SERVICE BULLETIN

M-1016

September 17, 1991

1991 FXDB STURGIS® JIFFY STAND SPRING AND ANCHOR PLATE

Jiffy Stand Spring and Anchor Plate - Exploded View

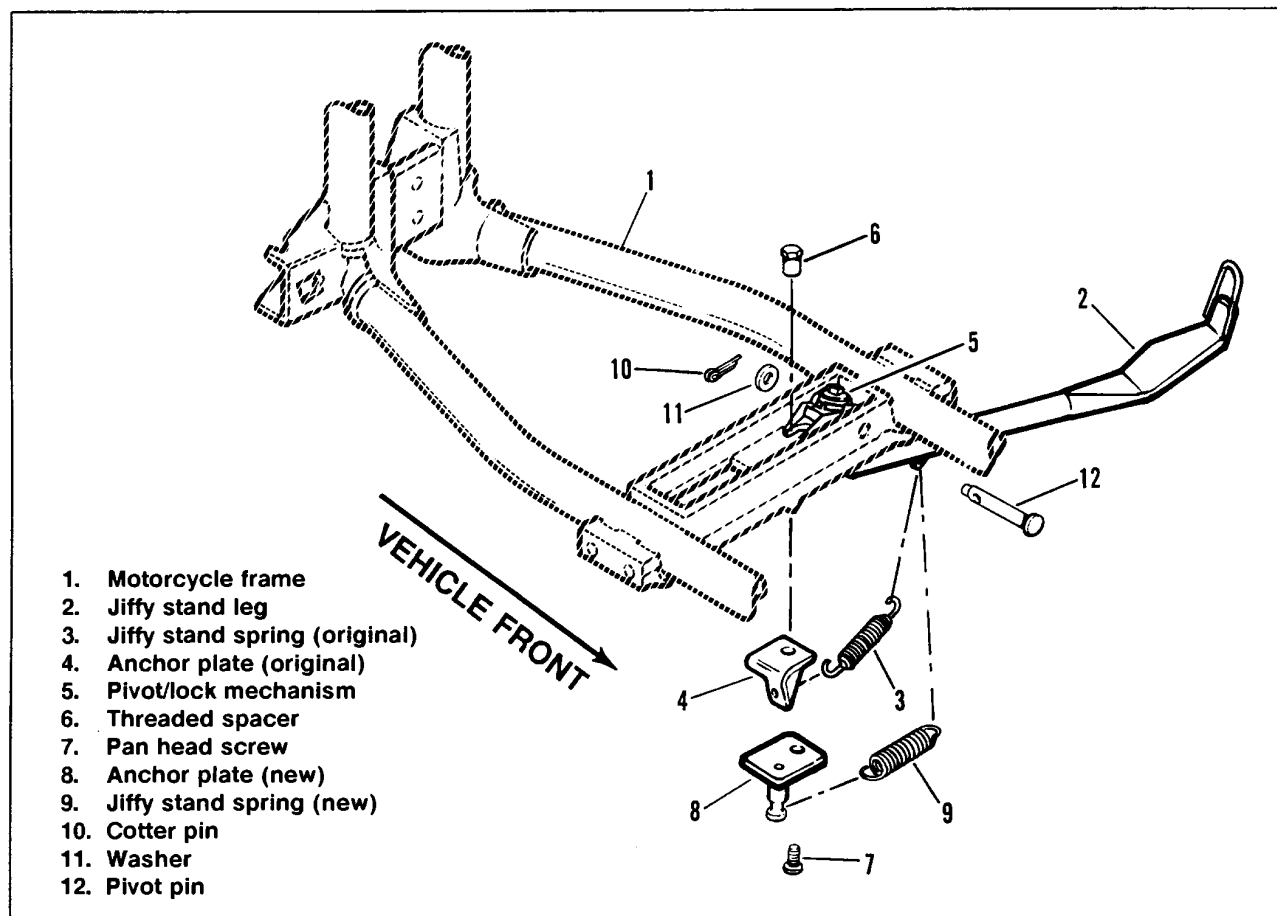
The jiffy stand spring tension on some 1991 FXDB Sturgis vehicles may relax somewhat over a period of time. If this occurs, the jiffy stand leg may not fully seat against its frame-mounted rubber bumper when the leg is retracted (up position).

Harley-Davidson has modified the design of the jiffy stand spring and anchor plate for improved jiffy stand leg retention against the rubber bumper. The new style spring and anchor plate should be installed as a set on 1991 FXDB Sturgis vehicles which exhibit a reduction in jiffy stand spring tension (see the Credit Procedure at the end of this Service Bulletin for warranty information). Use the Jiffy Stand Spring and Anchor Plate Kit (Part No. 47303-90A), which contains the following components:

The new style jiffy stand spring and anchor plate must be installed as a set. If you are installing a new style spring, you must also install the matching new style anchor plate (and vice versa). Improper operation of the jiffy stand assembly, or damage to the jiffy stand components, may otherwise result.

5. Unhook original spring (3) from jiffy stand leg and original anchor plate. Discard original spring.
6. Remove threaded spacer (6) and original T-40 Torx® pan head screw (7) in order to remove the original anchor plate (4), which is located beneath lower frame crossmember. Discard original anchor plate and original pan head screw.

8. Position new anchor plate (8) onto underside of lower frame crossmember so that the plate's anchor pin is pointing downward and is oriented to the right front corner of the plate as shown. Secure plate to crossmember using new T-40 Torx® pan head screw (7) and original threaded spacer (6). Tighten threaded spacer to 15 - 19 ft-lbs torque.

9. Hook either end of new spring (9) into original spring mounting hole on jiffy stand. Install other end of new spring over anchor pin of new anchor plate (8).

12. Apply a small amount of wheel bearing grease to anchor pin on new anchor plate (8). Extend and retract jiffy stand leg several times to check for proper operation of new spring and anchor plate. In retracted (up) position, jiffy stand leg should be securely seated against frame-mounted rubber bumper.
